GPU NUCLEAR

SEISMIC QUALIFICATION

No. SQ - T1 - NS-T-0001

DESCRIPTION NUC SVC CLOSED COOL SURGE TANK

Subject NS-T-1	VERIFIER'S CHECK NS-T-1 SEUS	Calc No. NS-T-1 SEUS	Rev. No. 0	Sheet No. B7 of 9
Originator <i>Shaden</i>	Date 10-14-93	Reviewed by N/A	Date

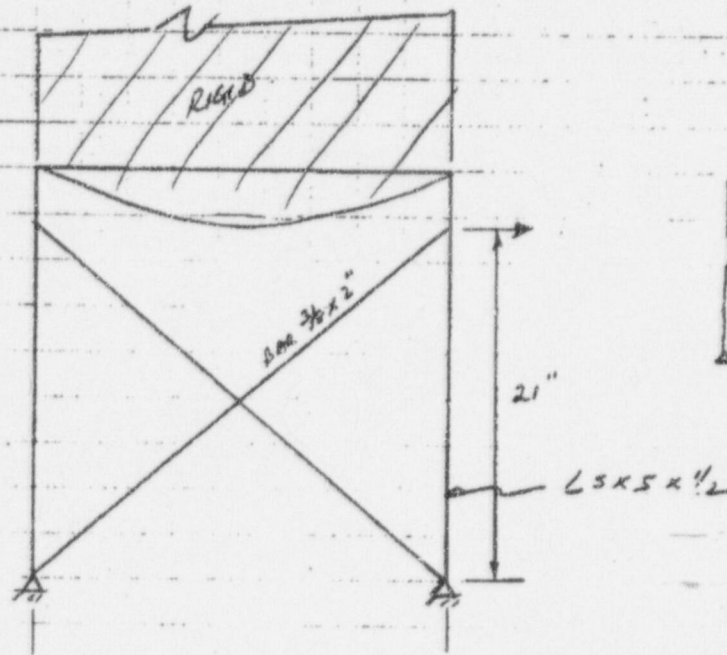
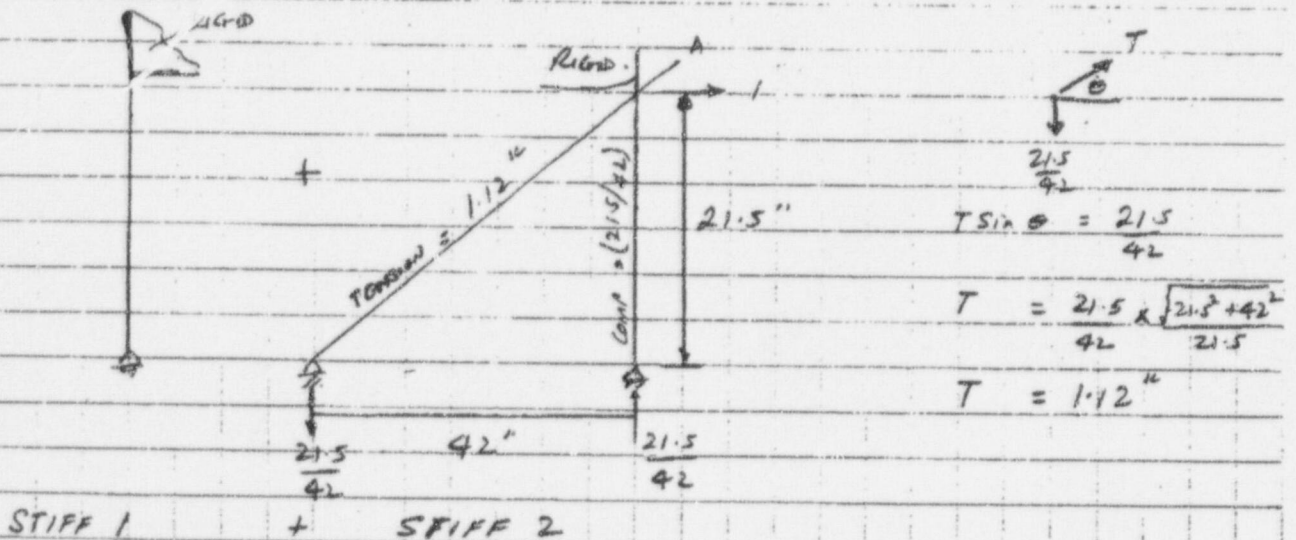
NOTE: SEE VERIFIER'S
CALC. Pg B7, & 59
FREQUENCY = 22 Hz

DETERMINE STIFFNESS OF FRAME

THE X BRACE ACTS TO RESIST TENSION ONLY. WHEN THE LOAD ACTS TO THE LEFT, THE STIFFNESS IS DERIVED FROM THE FOLLOWING TWO SYSTEMS.

$$f = \frac{1}{2\pi} \sqrt{\frac{8.52 \times 10^5}{43.65}} = 22.3 \text{ Hz}$$
